Errata for the WCT-15W1CFFPD

Document Number: WCT15W1CFFPDCE

Figure 1.

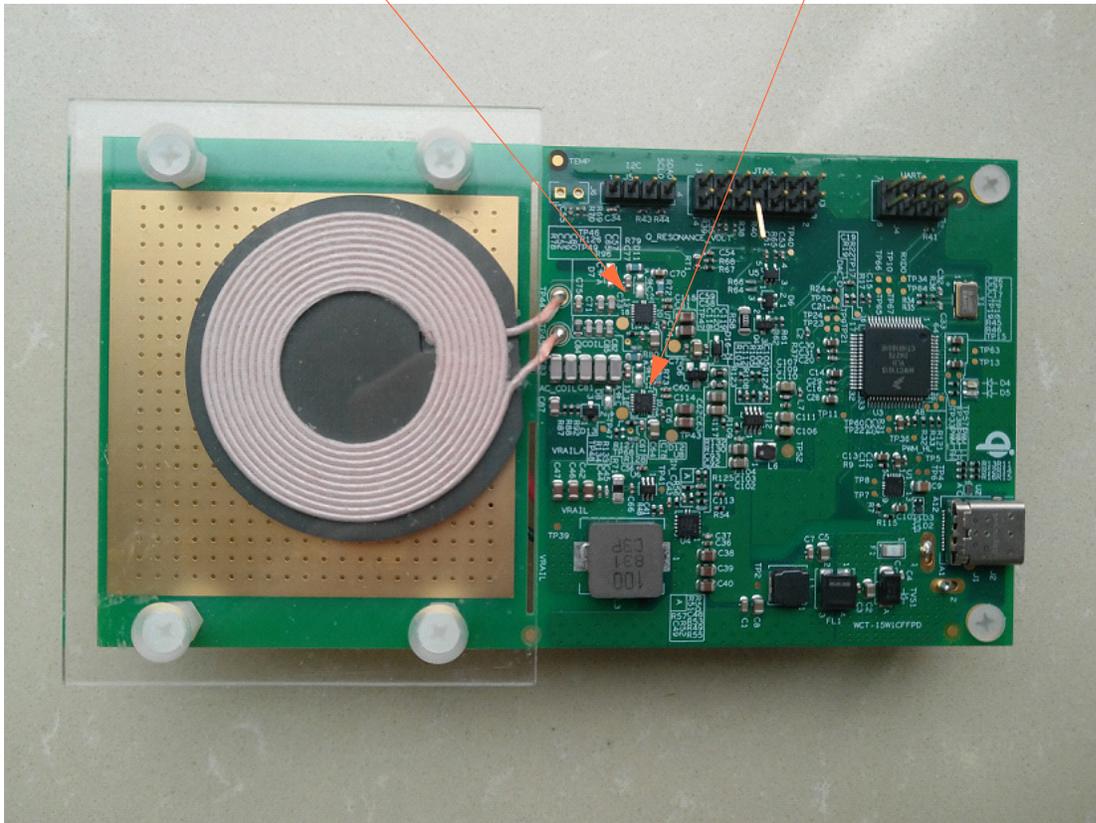
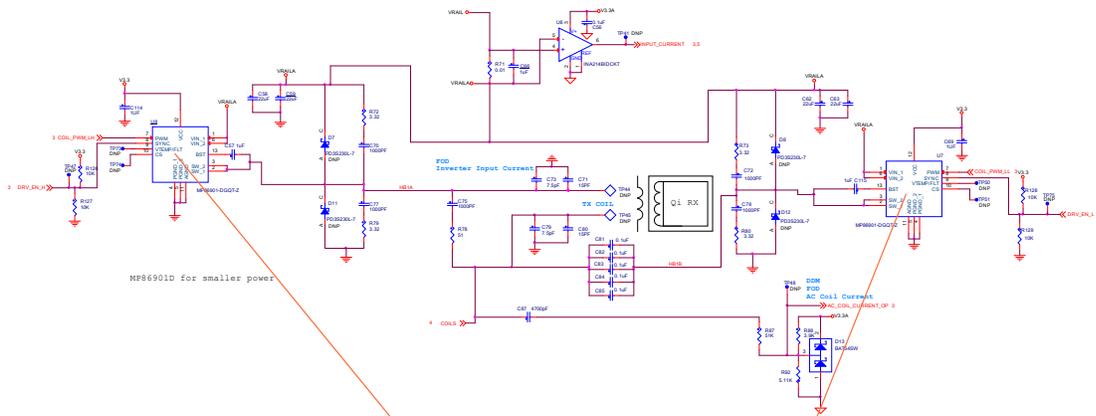
The U7 and U8 power stages are not the same chip with the SCH MP86901D.

The function and performance is similar, so you can use the demo board to evaluate all features of the WCT-15W1CFFPD.
